ARAPAHO ROAD PHASE III
 PLAN & PROFILE
STORM SEWER LINE 'A' STA. -1+84.79 TO STA. 0+85.21

TOWN OF ADDISON

G&A Grantham & Associates, Inc. SHT. SW-1

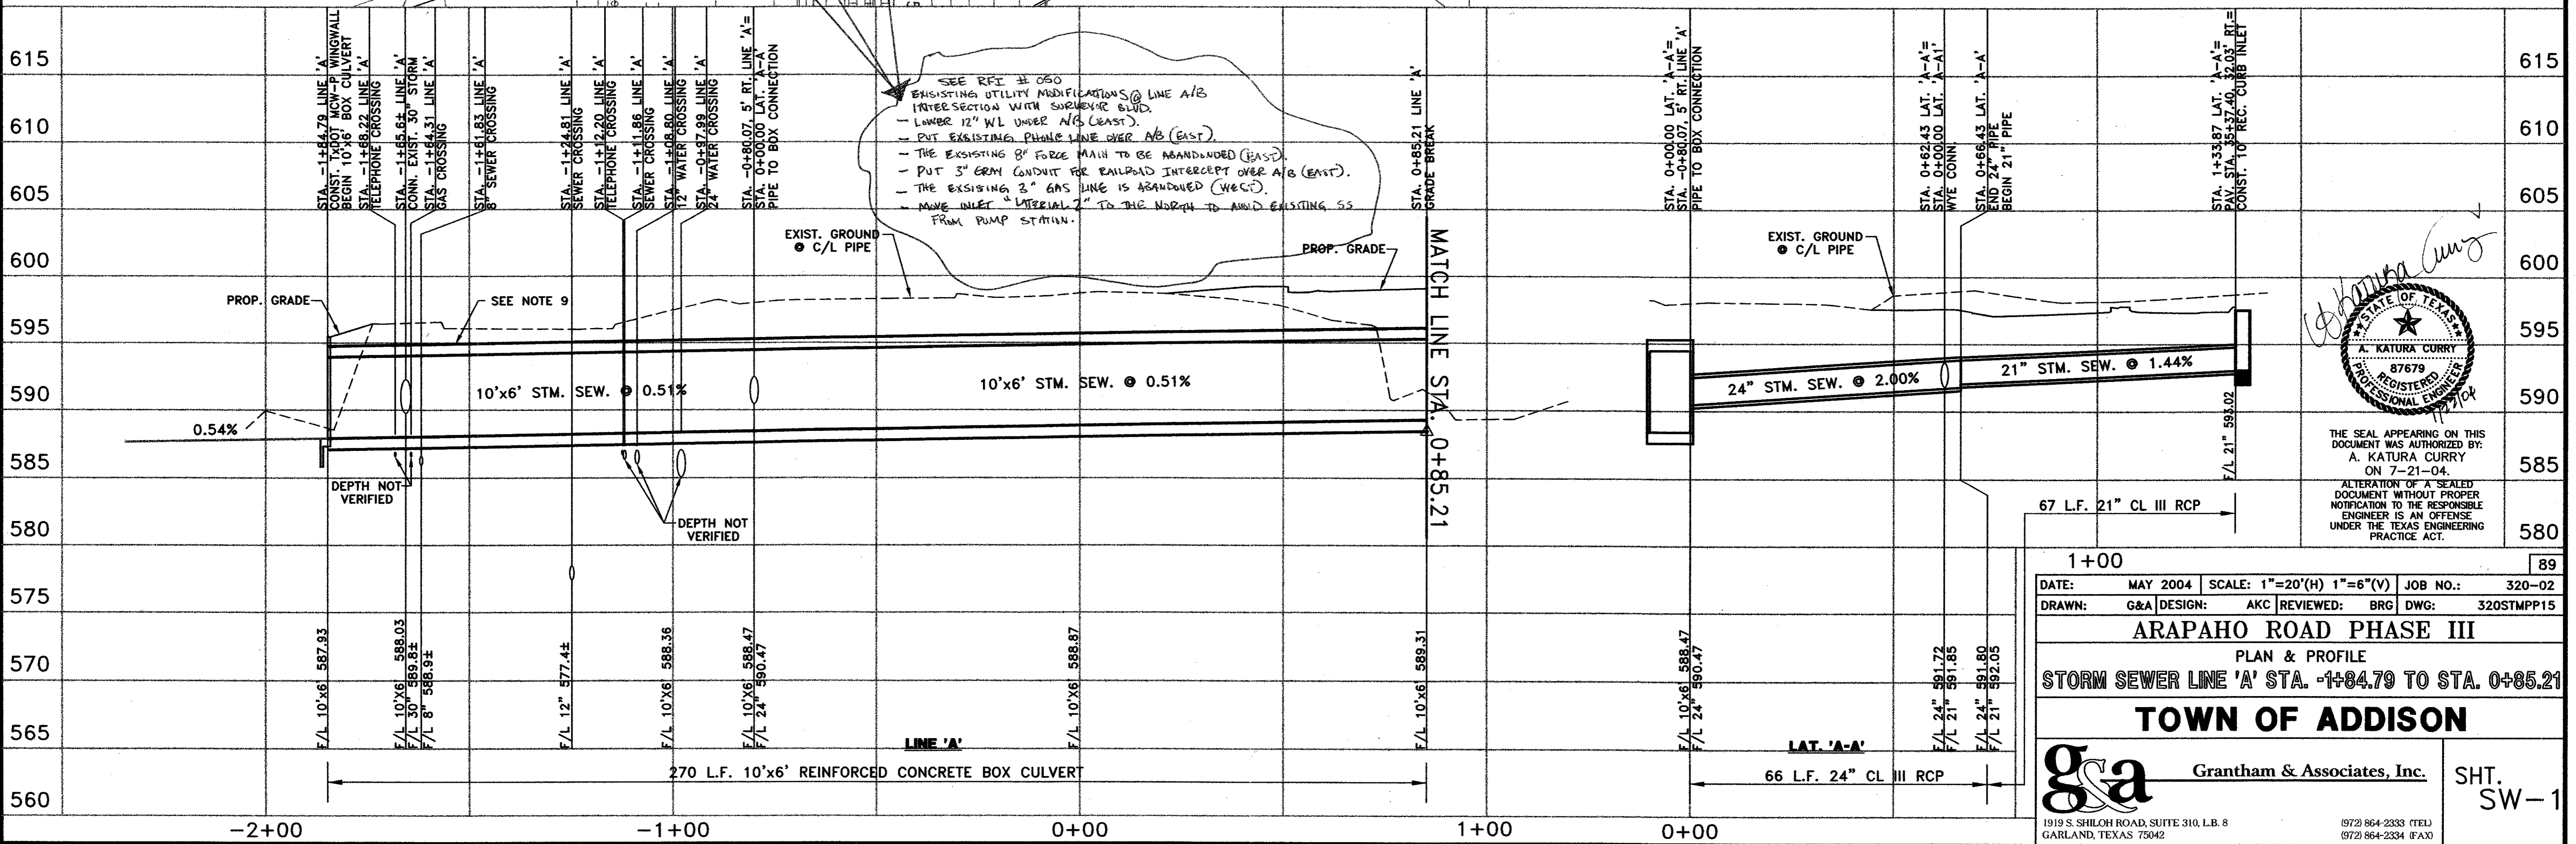
Conduit #7 As Built

Loc	STA	9/5	Top Conduit Elev
①	35182.14	60.854	595.66
②	35191.42	54.524	595.72
③	35193.20	53.724	585.13
④	36151.79	54.124	580.38
⑤	36161.63	54.184	596.22

SEE RFI # 027
(SEE SHEET # 21a)
GRADED PIPE DETAIL
